ATTACHMENT 4  
NRC DOCKETS 50-321, 50-366  
OPERATING LICENSES DPR-57, NPF-5  
EDWIN I. HATCH NUCLEAR PLANT UNITS 1 AND 2  
ADMINISTRATIVE TECHNICAL SPECIFICATIONS SUBMITTAL

The proposed change to the Technical Specification (Appendix B to the Operating License) would be incorporated as follows:

FIGURE 5.2-1

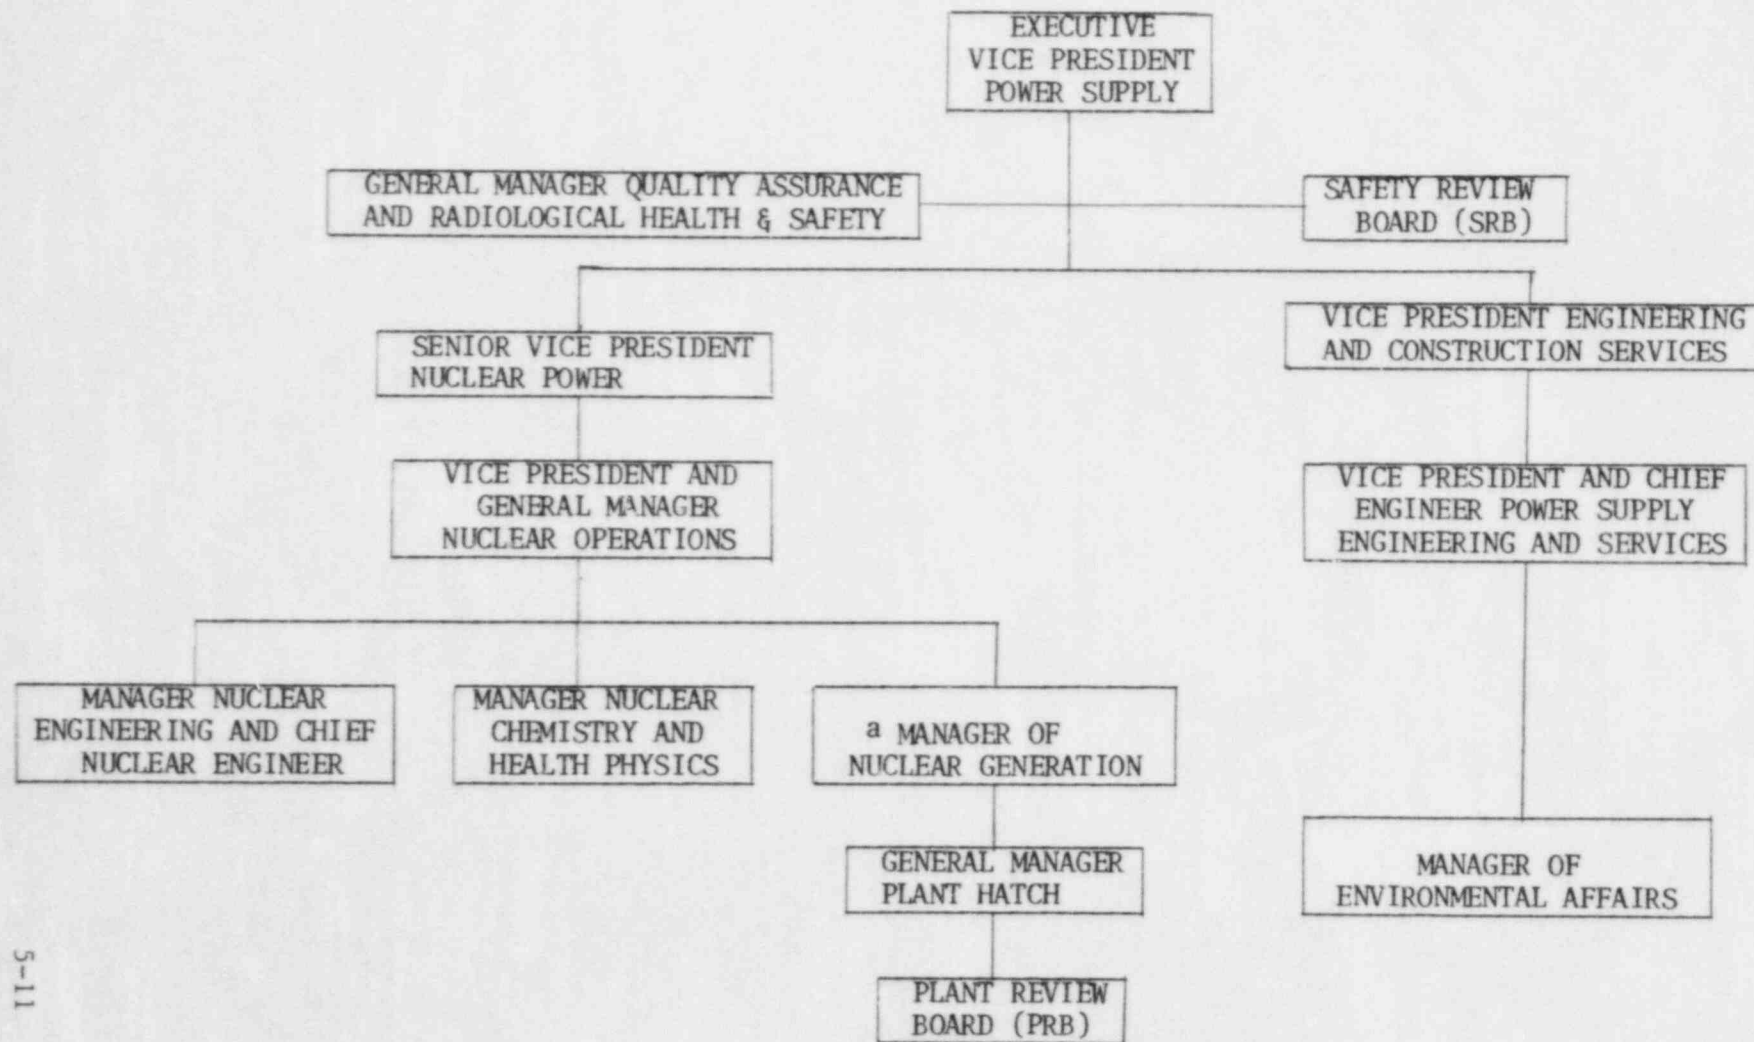
5.3.1.5 The Manager-Nuclear Engineering and Chief Nuclear Engineer shall review the following:

- a. Proposed changes to plant systems or equipment, provided that such changes are identified by the PRB as having a potential radiological environmental impact.
- b. Proposed changes to Section 3.2 of the ETS.

5.3.2.1 The General Manager of Quality Assurance and Radiological Health and Safety is responsible for an audit, conducted at least once a year, of the activities of the General Manager-Plant Hatch, the Manager of Environmental Affairs, and the Manager-Nuclear Engineering and Chief Nuclear Engineer related to compliance with the ETS.
